**TECHNICAL BULLETIN**  
**Bell Helicopter** **TEXTRON**

No. 214ST-02-168

**MODEL AFFECTED:** 214ST

**SUBJECT:** INTRODUCTION OF P/N 214-001-133-103  
COLLAR AND MODIFICATION OF EXISTING P/N  
214-001-133-001 COLLAR

FIGURE 1

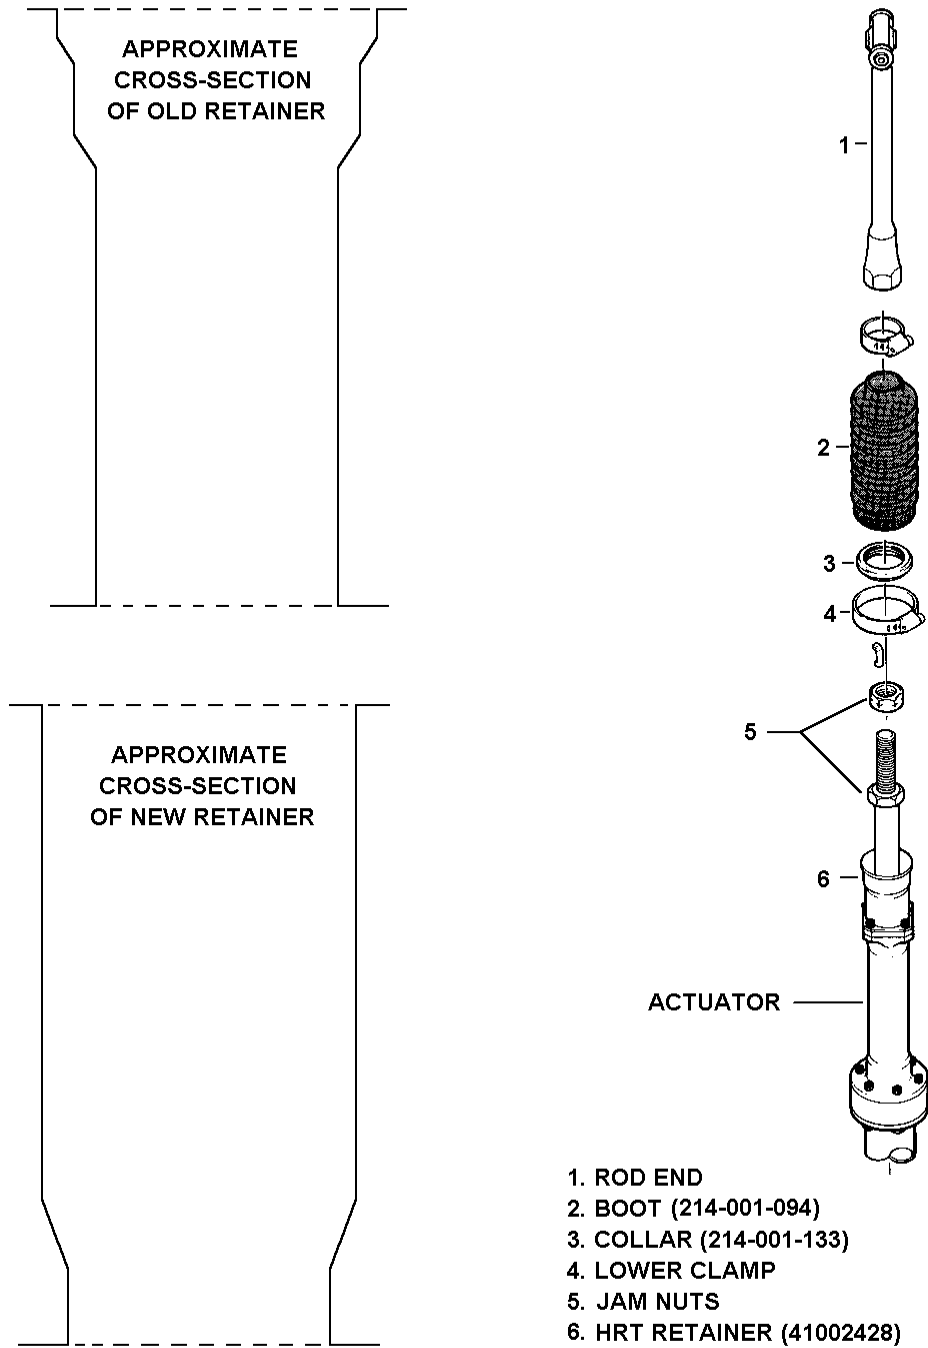
1. Refer to Figure 1 to determine differences between the old P/N 41002428 retainer and the new P/N 41002428 retainer. The P/N 214-001-133-103 Collar supersedes and replaces the -001 Collar.
2. Existing P/N 214-001-133-001 Collars may be field modified into the -103 configuration to fit new retainers as follows (see Figure 2):
  - a. Maintain the split line gap of 0.060 to 0.065 inches during the following steps.
  - b. Using a suitable method, lightly scribe, or mark, the new diameter on both outer surfaces of the collar flanges.
  - c. Using a suitable tool increase the inner diameter of both flanges evenly to the new diameter dimension. Deburr edges.

3. Refer to Figure 1. When installing the P/N 214-001-094 Boot (Item 2) over the P/N 214-001-133 Collar (Item 3) and securing with the clamp (Item 4), the collar must be free to rotate after the clamp is tightened.
